Department of Transportation

MEMORANDUM

SUBJECT: ZC Case No. 26-05 – 2100 M Street NW

Figure 1 | Site Plan (north arrow incorrectly pointing west, should be pointing to plan right)

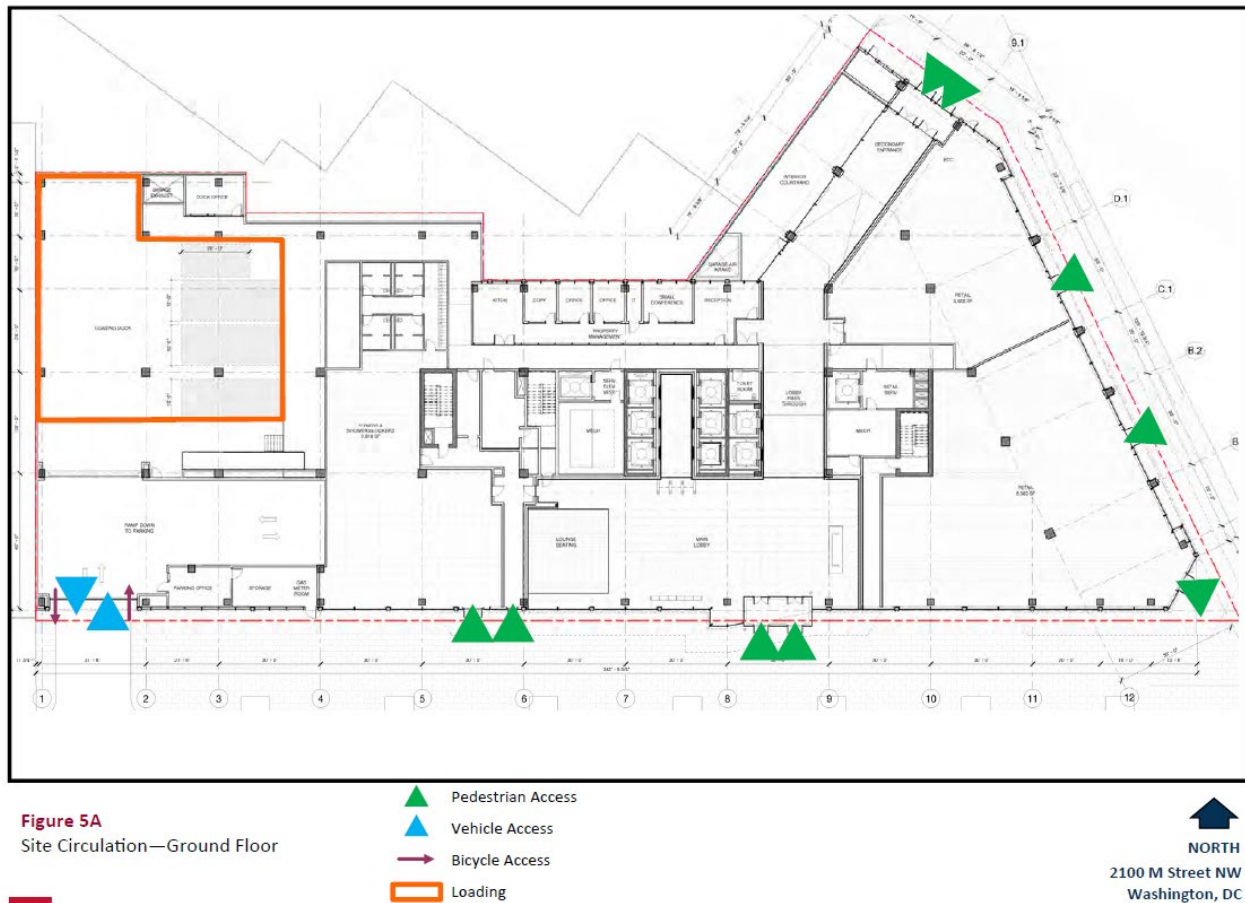
While the preliminary public space plans, shown above in Figure 1 are generally consistent with DDOT standards, the following considerations need to be reviewed in greater detail during the public space permitting process:

- All vehicular site access to the site, as well as loading facilities and trash pick-up, must be via the new/modified curb cut on 21st Street NW to meet DDOT standards;

- Remove the mid-block pedestrian crossing on 21st Street NW, returning the two curb cuts and to standard curb and streetscape furnishing area / tree box;

- Install intersection curb extensions at the crosswalks on M Street NW at both 21st Street and New Hampshire Avenue. The Applicant should attempt to harden both curb extensions by moving the physical curbs, otherwise install with striping and flex posts if one or both are infeasible, with the exact design to be determined and approved by DDOT during public space permitting;
